Number: E-04-003

## ENGINEERING DIRECTIVE

### DETECTABLE WARNING PANELS

Effective immediately, the *1996 Metric Edition Construction and Traffic Standard Details* and the *1977 [English Edition] Construction Standards* are amended with the following new drawings (attached):

**M/E 107.2.1     Wheelchair Ramp on Narrow Sidewalk**

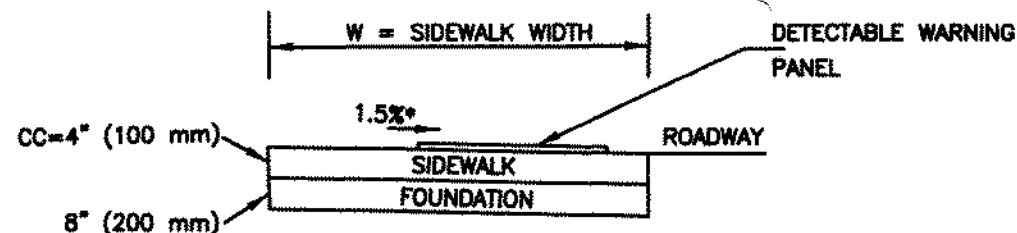
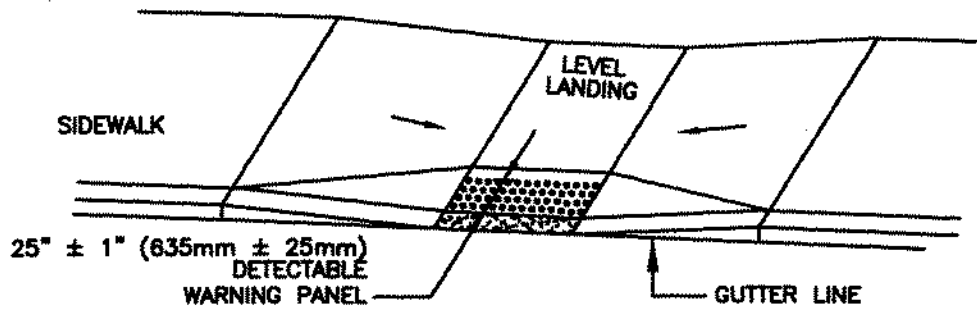
These drawings have been issued to comply with the FHWA enforcement of the Federal Access Board's decision to require detectable warning panels at certain locations. Detectable warning panels are intended to alert sight-impaired pedestrians that they are about to enter potentially hazardous locations. The drawings also include a new configuration of wheelchair ramps that can be used for narrow sidewalks.

Detectable warning panels shall be installed on all wheelchair ramps as shown on the drawings. Panels shall also be installed on all sidewalks that are crossed by train tracks to warn pedestrians that they are about to enter a track area. These panels shall be 25" (635 mm) long in the direction of travel and shall be installed across the entire sidewalk. The designer shall show the proposed location(s) of warning panels on the plans after consulting with the operator of the tracks about the safe envelope required around the tracks. The Resident Engineer shall verify the actual location(s) of warning panels with the operator of the tracks prior to installation.
